#### **INSTRUCTIONAL BULLETIN NO. 13-20**

#### **Regarding Revised Standard Drawings**

**Effective for the February 2014 Letting (December 4 turn-in)**, the following Standard Drawings are revised and Section V of the Design Guidelines is revised for this update.

10-15-02 RD01-TS-6

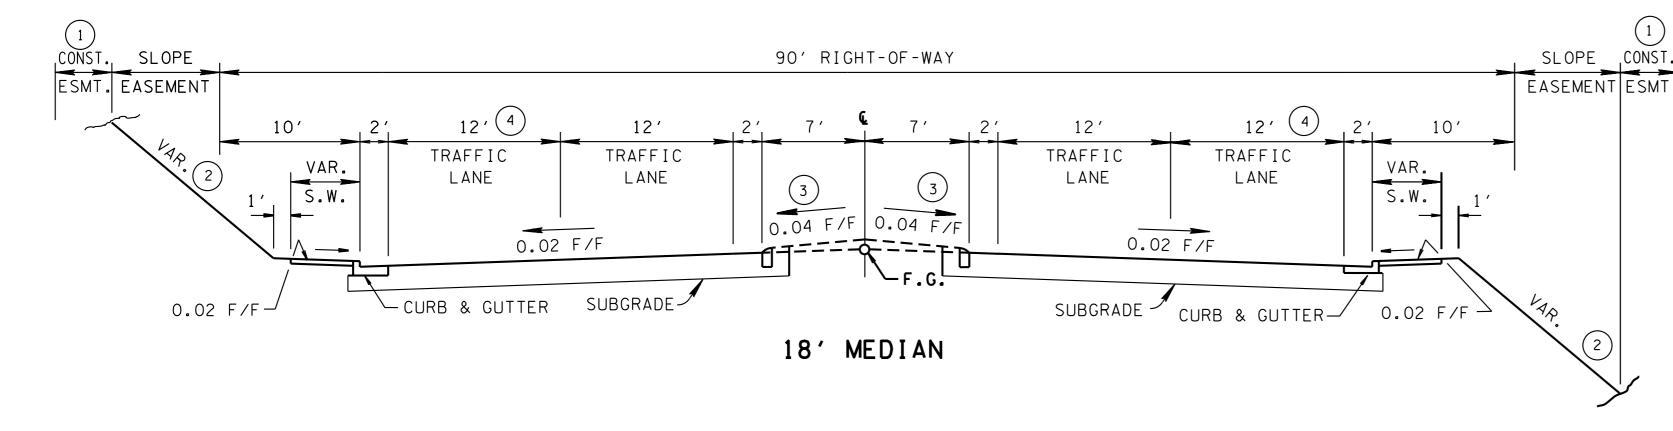
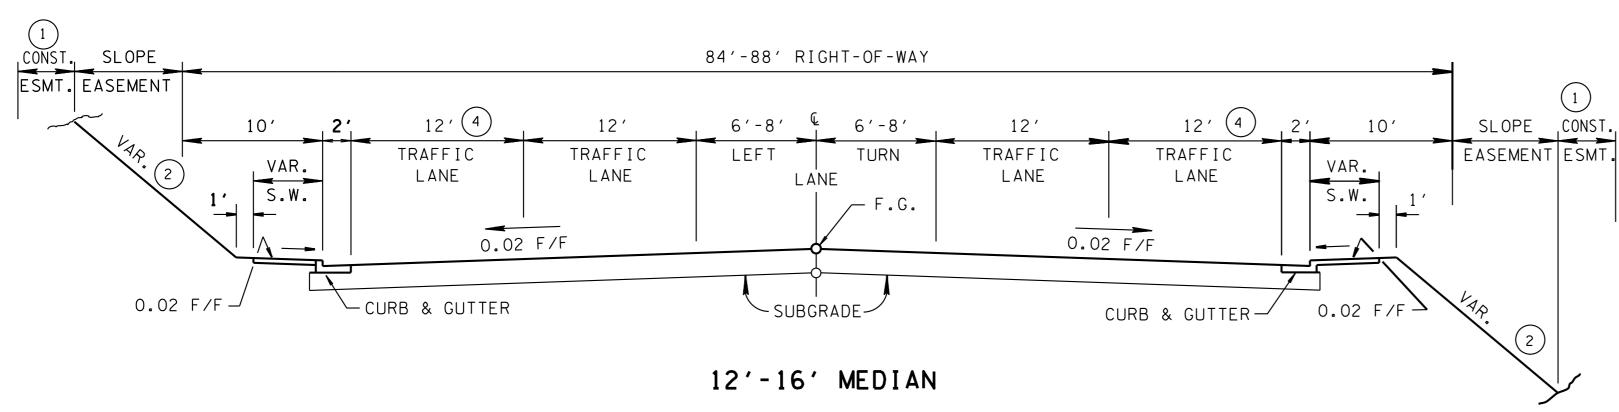
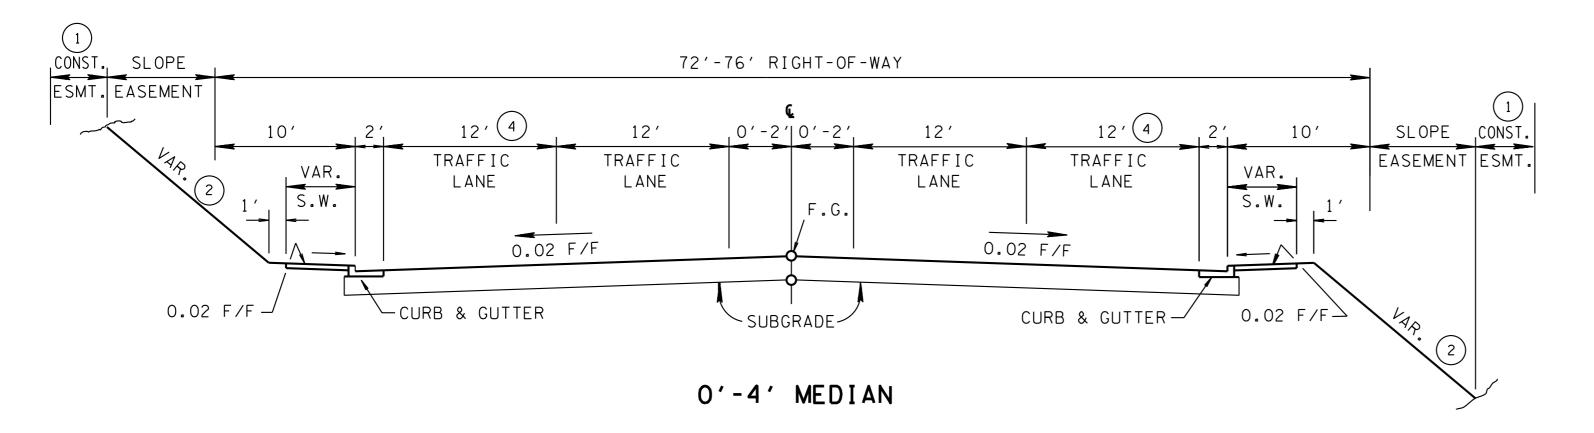
REV. 7-31-13: REVISED SIDEWALK WIDTH.

SIDEWALK WIDTH SHALL NOT INCLUDE THE SIX INCH WIDTH OF PROPOSED CURB, SIDEWALK SHALL BE A MINIMUM OF FIVE FEET WIDE.

10-15-02 RD01-TS-6A

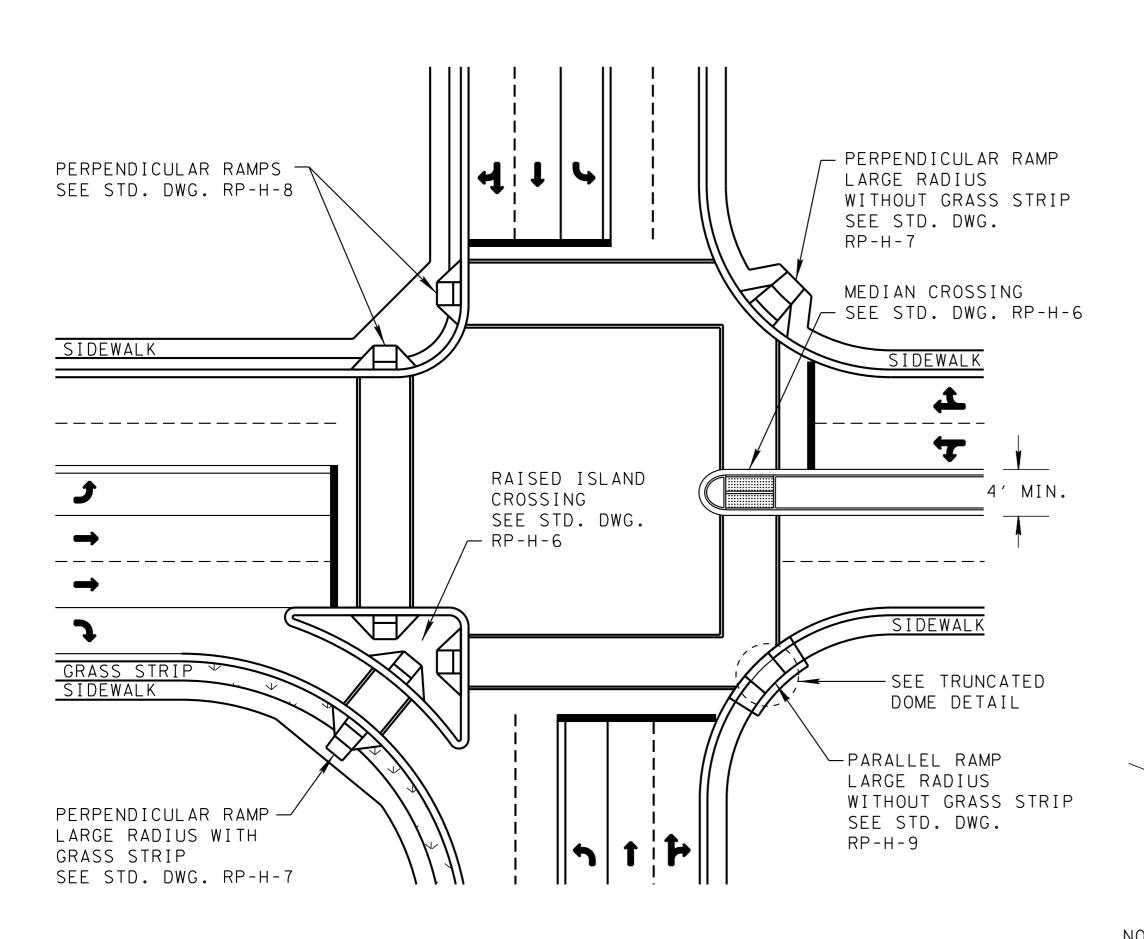
- REV. 1-24-12: ADDED REFERENCE TO NOTE 4.
- REV. 7-31-13: REVISED SIDEWALK WIDTH.

SIDEWALK WIDTH SHALL NOT INCLUDE THE SIX INCH WIDTH OF PROPOSED CURB, SIDEWALK SHALL BE A MINIMUM OF FIVE FEET WIDE.

CURB RAMP AND TRUNCATED DOME SURFACE DETAIL

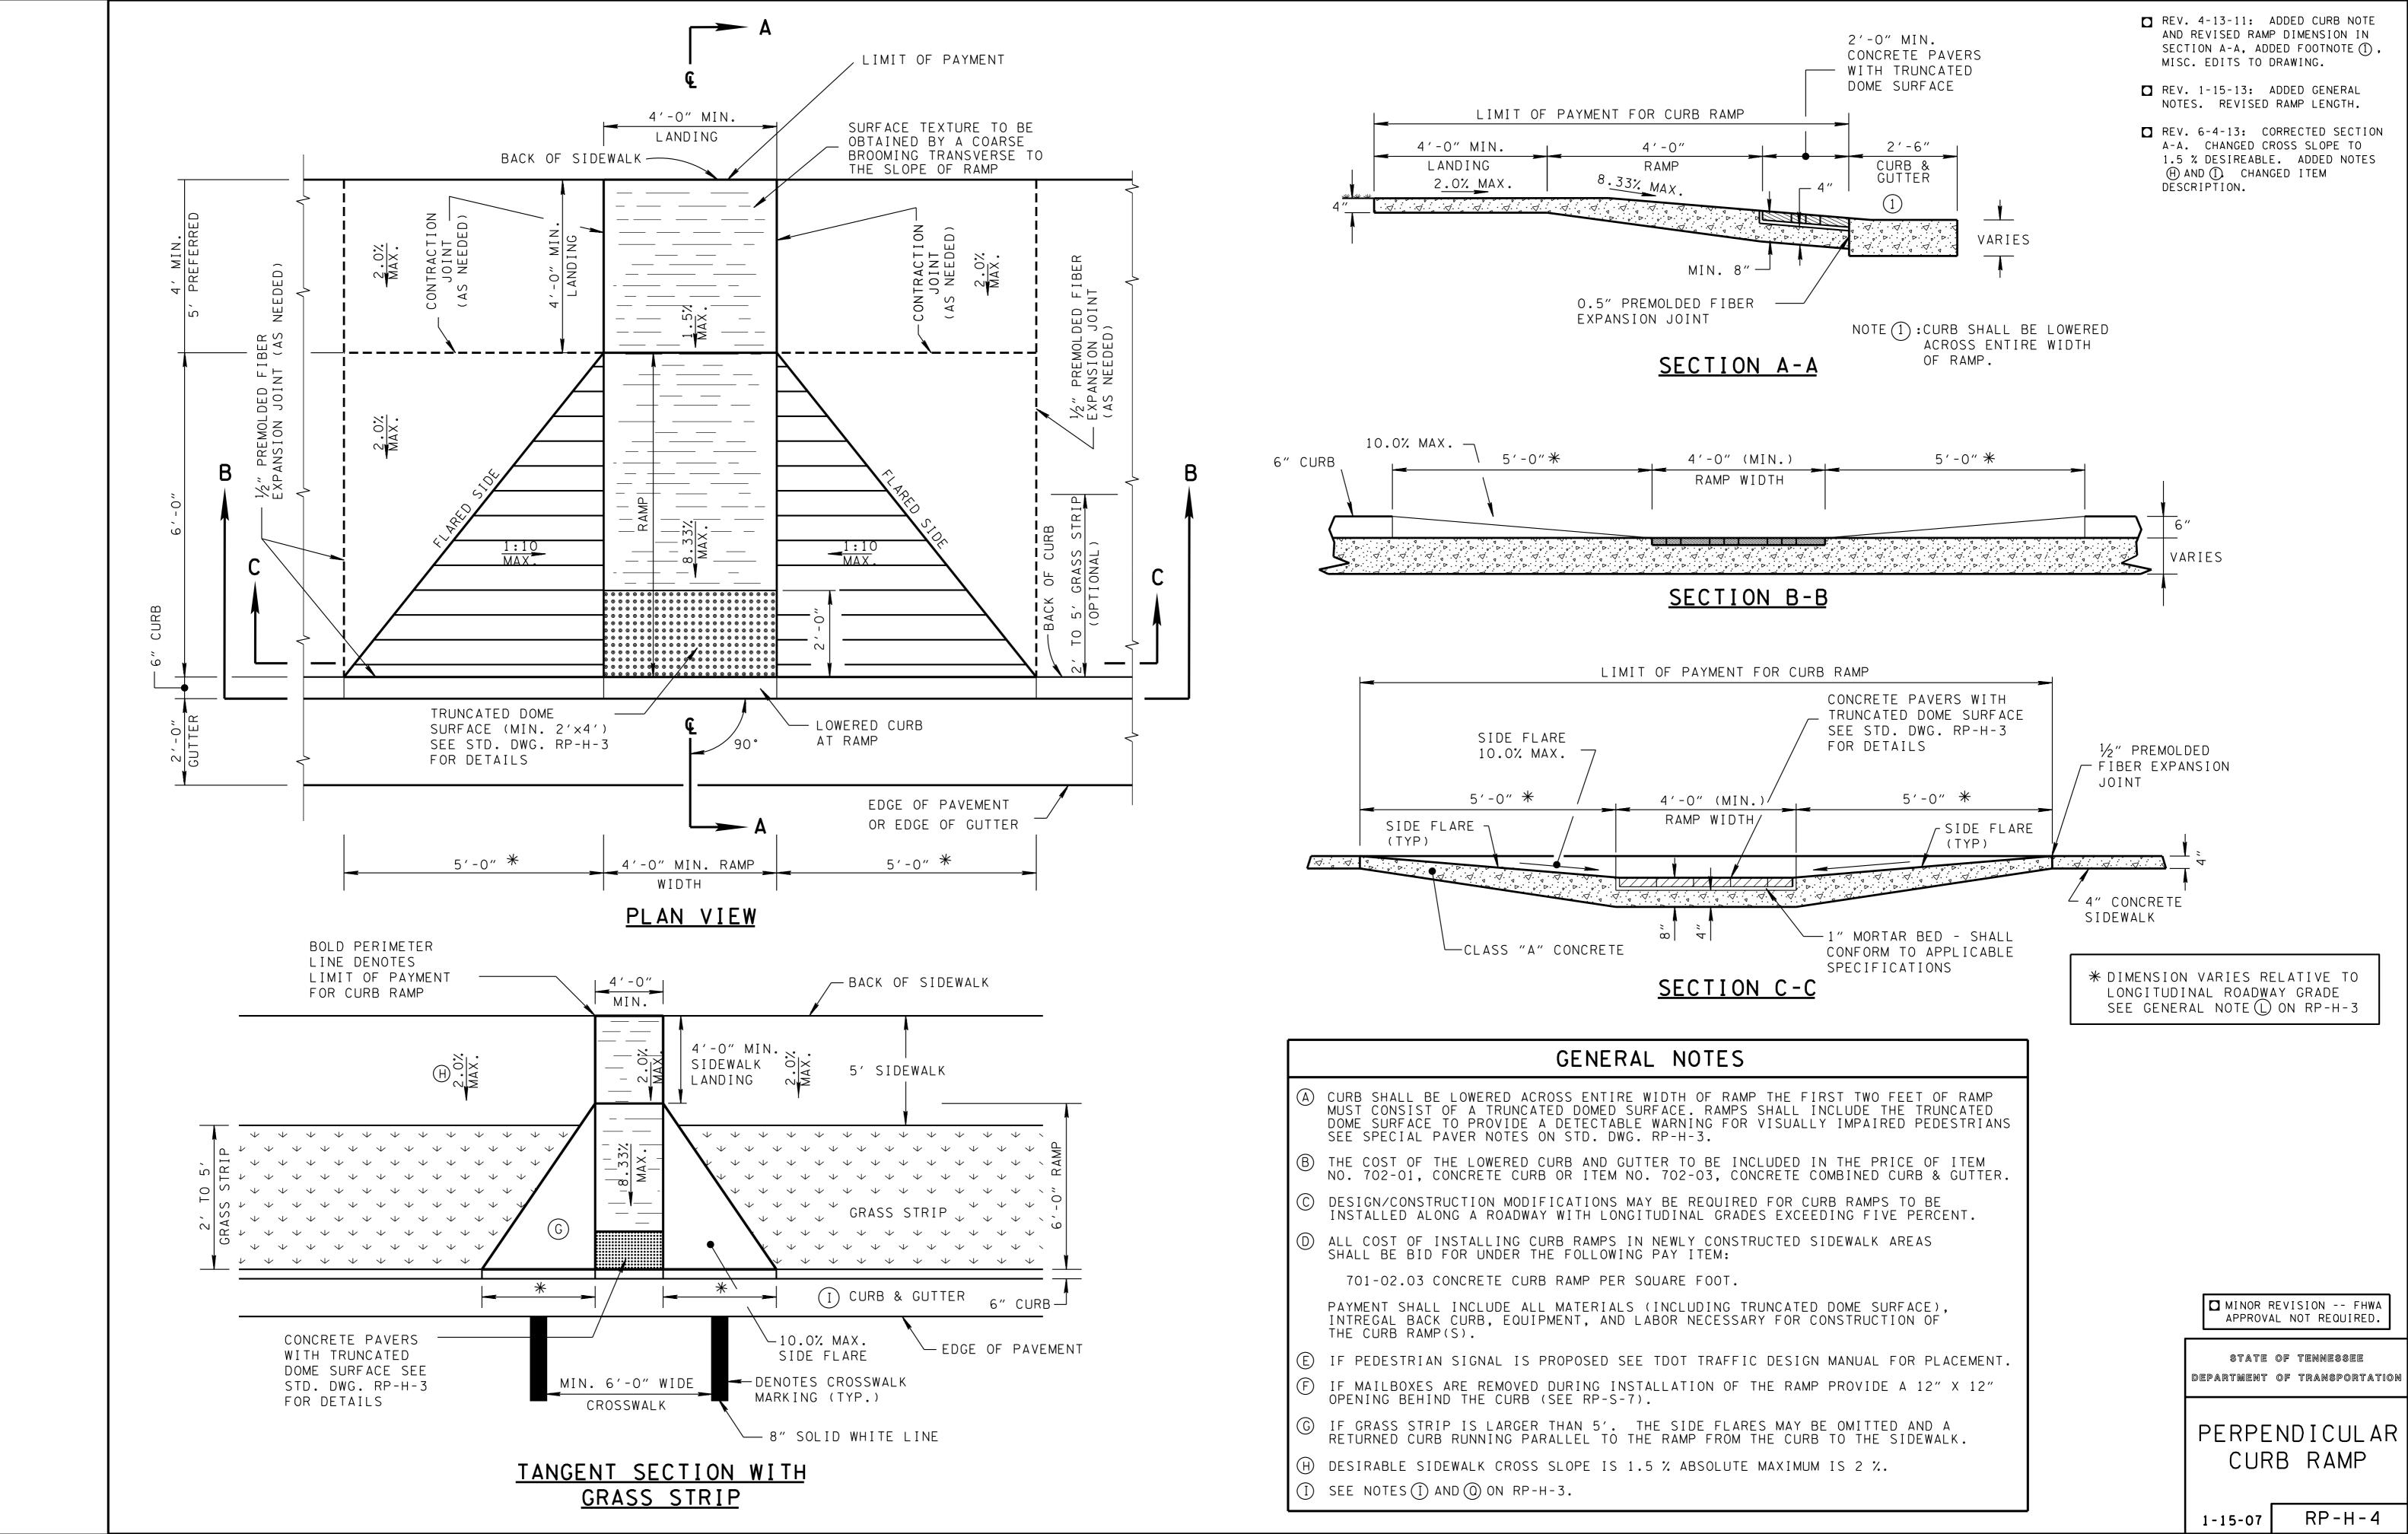
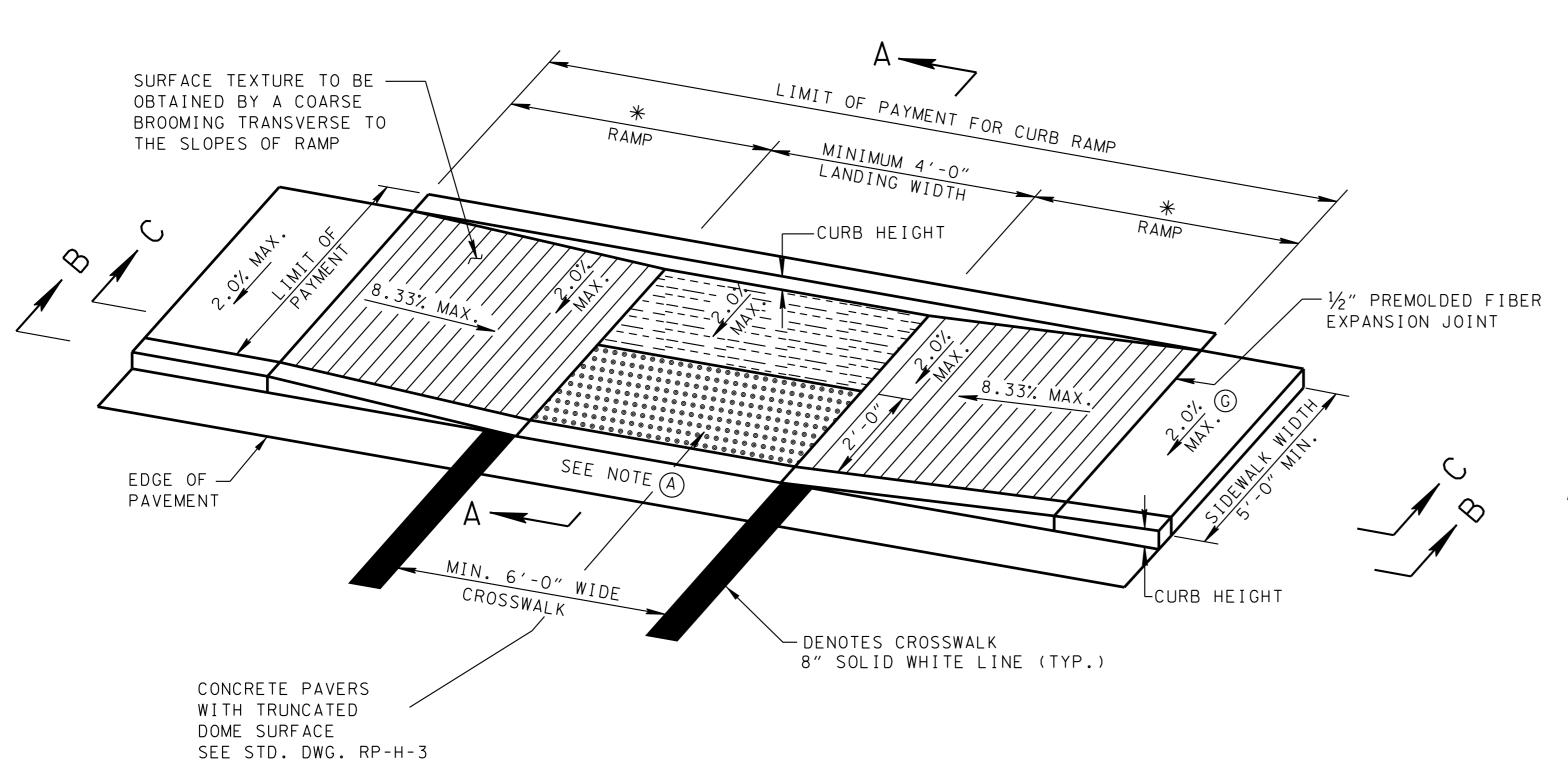
REV. 5-8-13: ADDED GUTTER SLOPE DETAIL AND REVISED NOTE (1), UPDATED TERMINOLOGY.

☐ REV. 6-4-13: ADDED SECTION A-A. CLARIFIED NOTE (I), ADDED NOTE (1). CHANGED ITEM DESCRIPTION.

- THE GUTTER LONGITUDINAL SLOPE SHALL MATCH THE ROADWAY AT
  THE RAMP AND THE GUTTER CROSS SLOPE AT THE RAMP SHALL NOT EXCEED 5%.
- (J) CROSSWALK MARKINGS, IF USED, SHALL BE LOCATED AS SHOWN ON THE APPLICABLE CURB RAMP STD. DWG. SEE STD. DWG. T-M-4 FOR TYPICAL STOP LINE PLACEMENT AND STANDARD CROSS WALK MARKING.
